UNITED STATES PATENT AND TRADEMARK OFFICE

APPLICATION NO.	FILING DATE	FIRST NAMED INVENTOR	ATTORNEY DOCKET NO.	CONFIRMATION NO.
10/070,037	02/26/2002	Meang K. Chia	B-4496PCT 619513-8	9827
36716	7590	08/10/2004	EXAMINER	
LADAS & PARRY 5670 WILSHIRE BOULEVARD, SUITE 2100 LOS ANGELES, CA 90036-5679			MITCHELL, KATHERINE W	
			ART UNIT	PAPER NUMBER

Office Action Summary

DETAILED ACTION

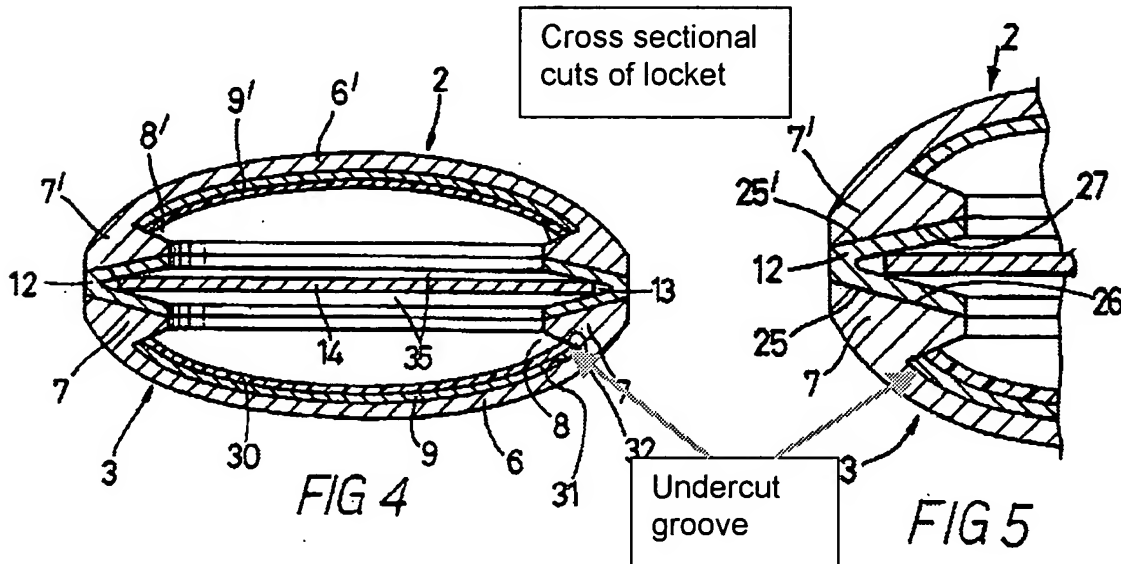
seen in Figs 1-4 and described in column 2 line 2 - column 3 line 64. Referring to base member 3, the back section or cover, the base member 3 has:

- a hollow interior (fig 4, #8, described in column 2 lines 63-66)

- a top with an opening therein leading to said hollow interior (cover rim surface 25 seen in Fig 5 and column 2 lines 63-64)
- a bottom (6)
- and a sidewall extending from said top to said bottom (# 7 in Fig 4 and 5 and described in column 1 lines 52-56);
- a decorative insert configured and sized in relation to base member top opening to be inserted through top opening into said hollow interior and entirely positioned below said top (photograph 9. column 2 lines 66 - column 3 line 2)
- said decorative insert fixed within hollow interior with said insert viewable through said top opening (photograph 9 is covered with plastic panel 30, thus is inherently viewable through top opening formed by 25).

FIG 7

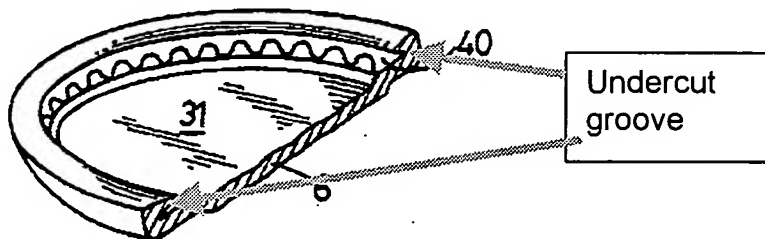
Re claims 132 and 140: A support member fixed to said base member within said hollow interior (toughened area 40, Fig 7, comprising projections and indentations which helps to support and retain decorative item 9, column 3 lines 55-64) and wherein said decorative insert is captured within said base member between said base member top and said support member. Note that, comparing Figs 5 and 6, the insert 9 extends in Fig 5 to the undercut groove (labeled by examiner above), described in column 2 lines 19-25 as extending "under the annular wall of the cover",

and that when decorative photo 9 is placed into hollow section as shown in Fig 5, it would be atop 40 and thus it would be between top 25 and support 40.

Re claim 136: As best understood by examiner, the support member of claim 133 comprises a "plate-like" member fixed within said base member below said top as shown in Fig 7. Examiner is assuming "plate-like" to mean relatively thin relative to the diameter or circumference.
